Product Change Notification - SYST-10IADJ364

ERRATA - dsPIC33EPXXGS202 Family Silicon Errata and Data Sheet Clarification

1) Adds new silicon issue 35

dsPIC33EPXXGS202 Family Silicon Errata and Data Sheet Clarification

FIGURE 1: EXAMPLE FOR REDUNDANT OUTPUT MODE

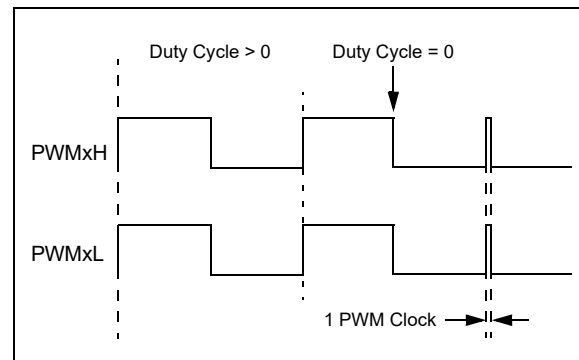
7. Module: PWM

In the Redundant Output mode (`IOCONx[11:10] = 0b01`) and Push-Pull Output mode (`IOCONx[11:10] = 0b10`), with the Immediate Update Enable bit disabled (`PWMCONx[0] = 0`), when the Duty Cycle register is updated from a non-zero value to zero, a glitch pulse of a width equal to one PWM clock will appear at the next PWM period boundary, as shown in Figure 1 (for the Redundant Output mode). The Duty Cycle register refers to the `PDCx` register if `PWMCONx[8] = 0` or the `MDC` register if `PWMCONx[8] = 1`.

Work around

If the application requires a zero duty cycle output, there are two possible work around methods:

1. Use the PWM override feature to override the PWM output to a low state instead of writing to the Duty Cycle register. In order to switch back to a non-zero duty cycle output, turn off the PWM override. The override-on and override-off events must be timed close to the PWM period boundary if the `IOCONx` register has been configured with `IOCONx[0] = 0` (i.e., output overrides through the `OVDDAT[1:0]` bits occur on the next CPU clock boundary).
2. Enable the Immediate Update Enable bit (`PWMCONx[0] = 1`) while configuring the PWMx module (i.e., before enabling the PWMx module, `PTCON[15] = 1`). With the Immediate Update enabled, writes to the Duty Cycle register can have an immediate effect on the PWM output. Therefore, the duty cycle write operations must be timed close to the PWM period boundary in order to avoid distortions in the PWM output.

FIGURE 2:

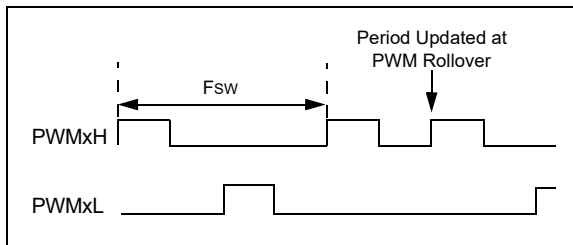
9. Module: PWM

When the PWM module is configured for Push-Pull mode (IOCONx[11:10] = 0b10) with the Enable Immediate Period Update bit enabled (PTCON[10] = 1), a write to the Period register that coincides with the period rollover event may cause the push-pull output logic to produce back-to-back pulses on the PWMx pins (Figure 2).

Work around

If the EIPU bit is set (PTCON[10] = 1), ensure that the update to the PWM Period register occurs away from the PWM rollover event. Use either the PWM Special Event Trigger (SEVTCMP) or the PWM Primary Trigger (TRIGx) to generate a PWM Interrupt Service Routine (ISR) near the start of the PWM cycle. The PWM Period register could be updated inside this ISR so that the period writes do not occur near the PWM period rollover event.

FIGURE 3: MISMATCH OF WORKING REGISTER SET WHEN NESTING MORE THAN ONE INTERRUPT WITHIN INTERRUPTS THAT USE ALTERNATE WORKING REGISTER SETS

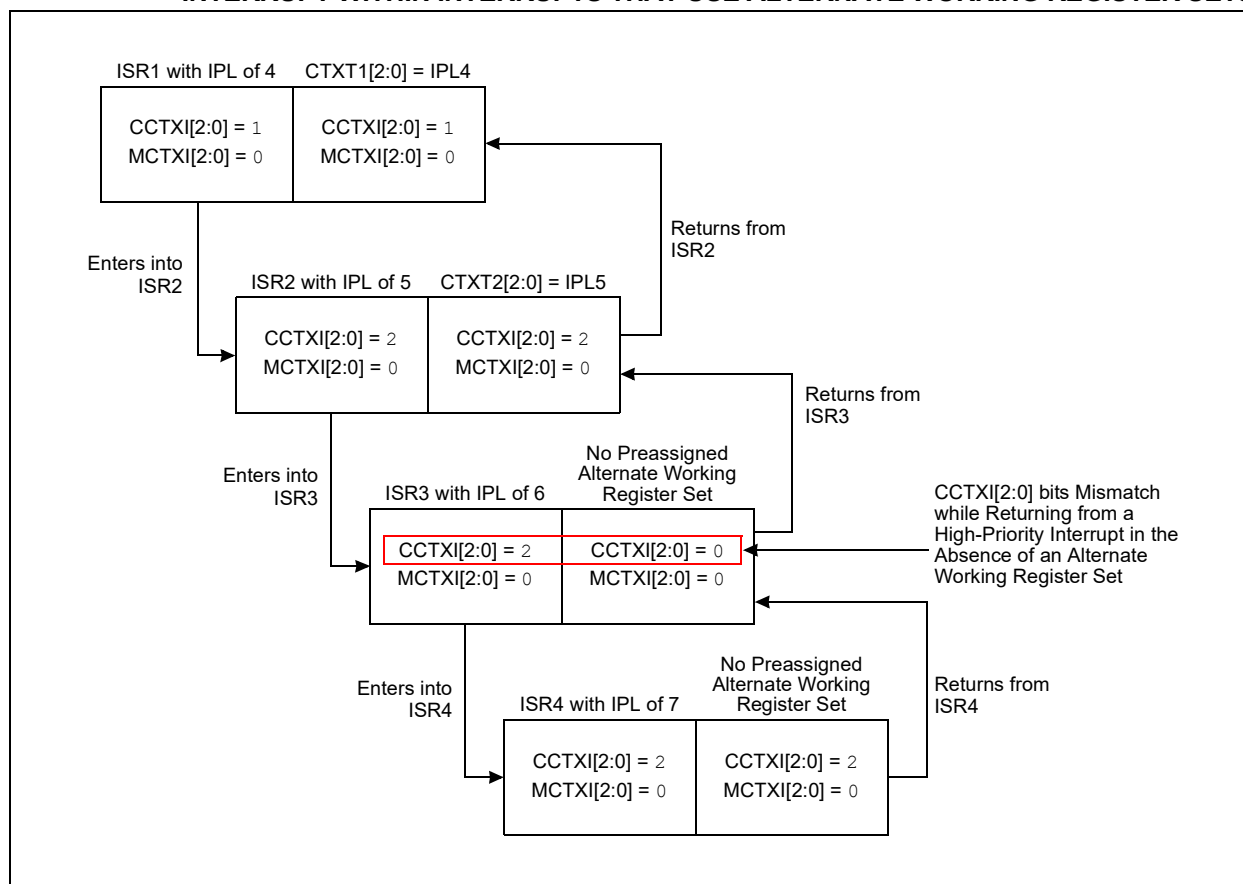
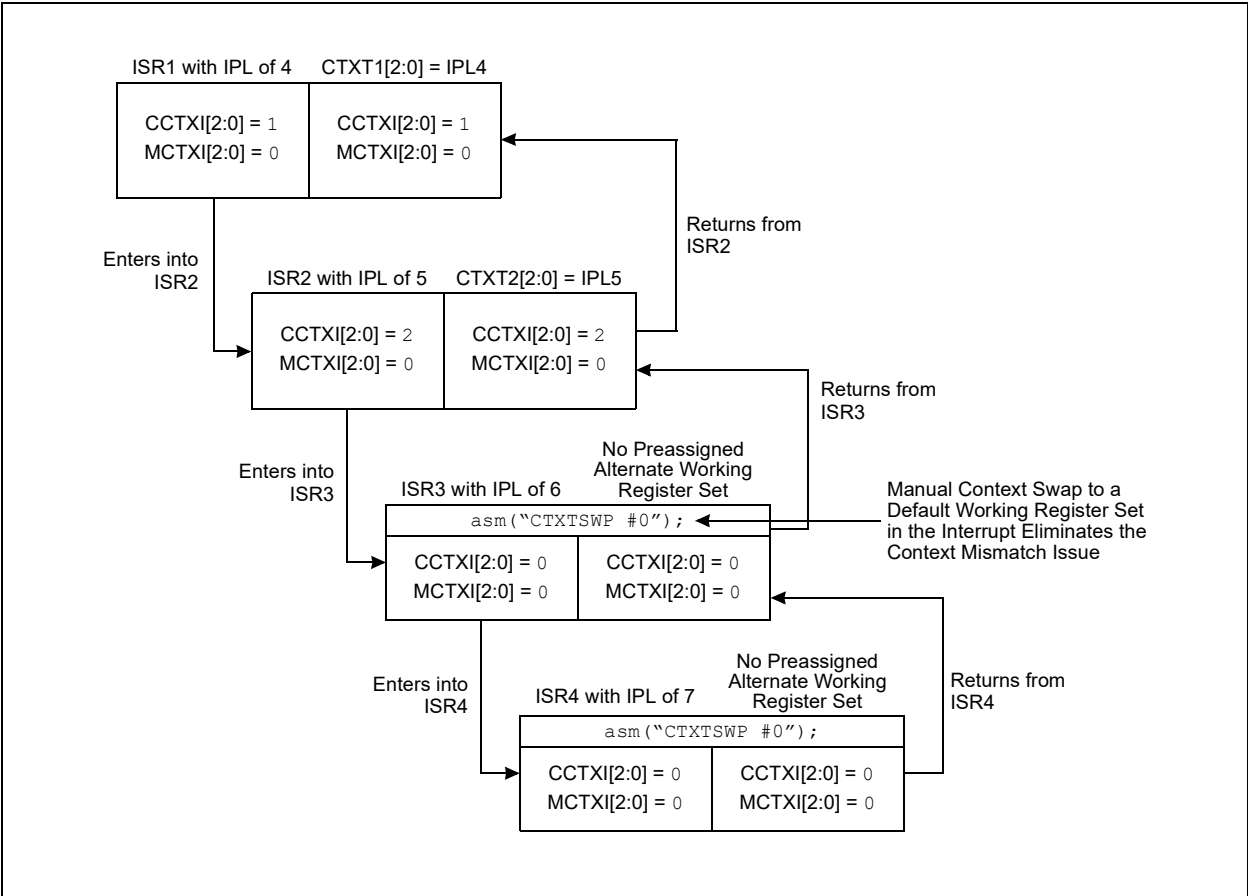
21. Module: CPU

When returning from an Interrupt Service Routine (ISR) by executing the `RETFIE` instruction, in the case of a nested interrupt, the Interrupt Priority bits (`IPC[3:0]`) associated with the lower priority interrupt are compared with the `CTXTn` bits field in the `FLTREG` Configuration register:

When using interrupts with the Alternate Working Register Set (automatic context assignment), no more than one ISR without an Alternate Working Register Set must be nested within an ISR with an Alternate Working Register Set.

Issue and work around are illustrated in [Figure 3](#) and [Figure 4](#), respectively. The figures show the status bits, `CCTXI[2:0]` and `MCTXI[2:0]`, after entering into an ISR from a lower priority ISR (left pane), and after returning to the same ISR from a higher priority ISR (right pane).

Work around

Work around 1: When using interrupts with the Alternate Working Register Set, at the entry of all ISRs that do not have an Alternate Working Register Set and have a higher IPL level than the ISRs with an Alternate Working Register Set, perform a manual context swap to Context #0 as:

```
asm("CTXTSWP #0");
```

Note: The application software must not perform a manual context swap (using the CTXTSWP instruction) to a context other than Context #0.

Work around 2: Always assign higher IPLs for the ISRs that use an Alternate Working Register Set than for the ISRs that do not use an Alternate Working Register Set.

FIGURE 5: SIMPLIFIED BEHAVIOR

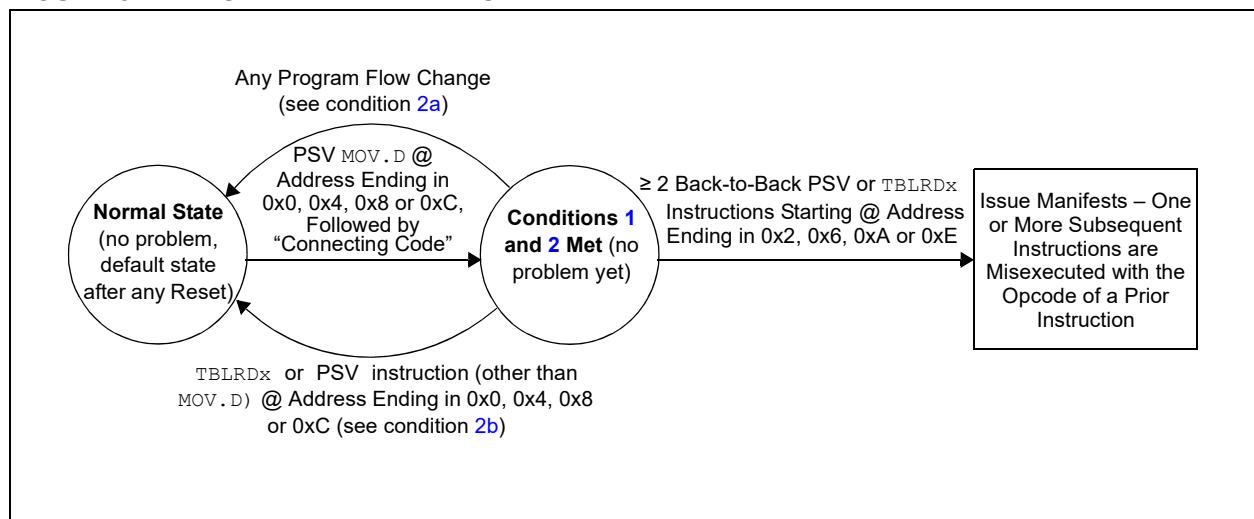
28. Module: CPU

When two or more data Flash read instructions (via Program Space Visibility (PSV) read or table read) are executed back-to-back, one or more subsequent instructions can be misexecuted when all of the conditions in [Table 4](#) occur.

[Figure 5](#) provides an example of the effective behavior.

Work around

The issue can be avoided by ensuring any one or more of the requirements are not met. For example:

1. All instances of PSV MOV.D can be replaced with two PSV MOV instructions instead. Non-PSV MOV.D instructions acting on RAM/SFRs do not need to be modified; or
2. If not already present, a program flow change instruction (such as BRA \$+2) can be inserted above back-to-back data Flash read sequences; or
3. Back-to-back data Flash read instruction sequences can be broken up by inserting a non-Flash read instruction (such as a NOP), in between the Flash read instructions; or
4. The alignment of the code can be shifted to avoid the required opcode location addresses.

C code built with MPLAB® XC16 Compiler Version 1.32, or later, implements the work around by default. However, if the application uses Assembly language routines, these should be manually modified to implement the work around. Additionally, if precompiled libraries are used, these should be built with XC16 Version 1.32 or later. For additional information, please visit: www.microchip.com/erratum_psr_d_psr_d

FIGURE 6: I/O RAMP

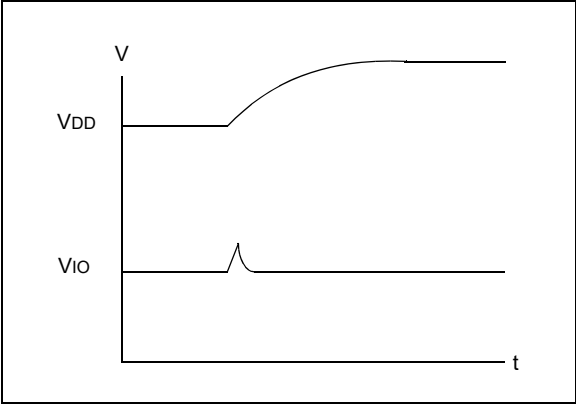
35. Module: I/O

During device power-up, the I/O pins may drive up to 100 μ A current for a duration of up to 300 μ S. (Figure 6).

Work around

Ensure the circuitry that is connected to the pins can endure this pulse.

Example applications affected may include complementary power switches, where a transient current shoot-through might occur. High-voltage applications with complementary switches should power the high-voltage 3 mS later than powering the dsPIC® device to avoid the current shoot-through. This behavior is specific to each device and not affected by aging.
